SERVICE BULLETIN #3 HOUDINI SKILL SHOT FIX

May 15, 2018

These steps need to be performed if you are unable to hit all 3 targets for the skill shot.

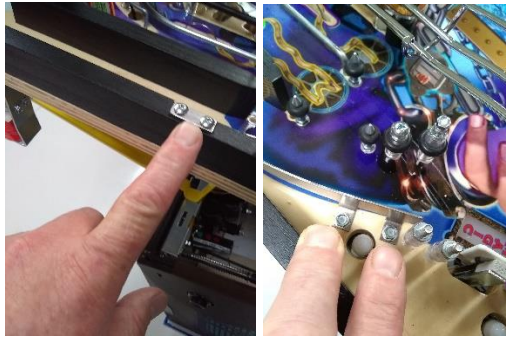
Remove the three 11/32 nuts, remove and disconnect the planchette and loosen the three Philips heads

Remove the two 1/4" nuts holding the gate on and remove the gate.

Remove the two Philips and two ¼" screws

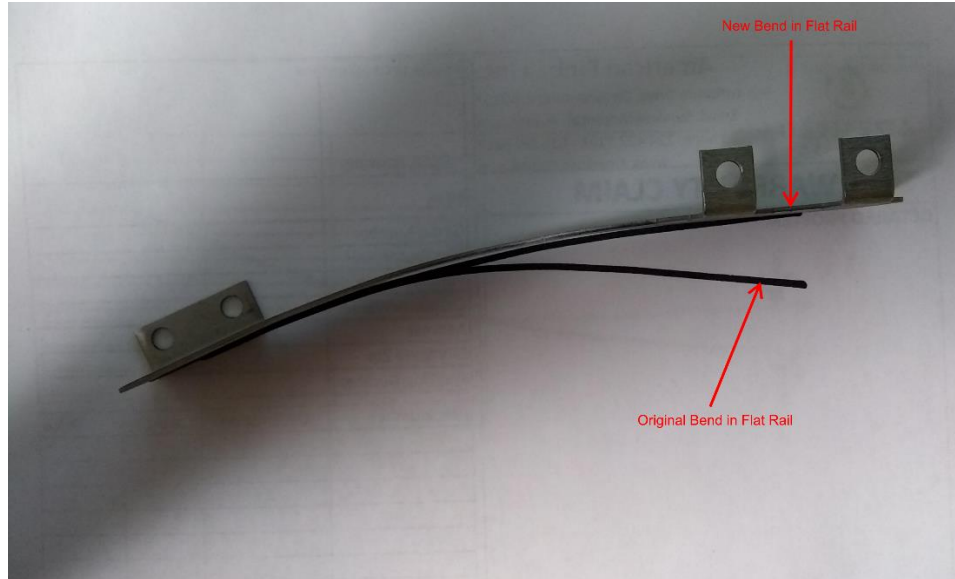
Remove the flat rail and open the radius of the curve about 1 inch.

Remove the 7/16" rubber and insert the 3/16" rubber. The post closest to the flat rail will no longer have a rubber on it. The goal is to have the flat rail touching the post without the rubber on it.

Reinstall the gate, plastic and planchet. Test to ensure the ability to hit all three stand up targets from the shooter lane.
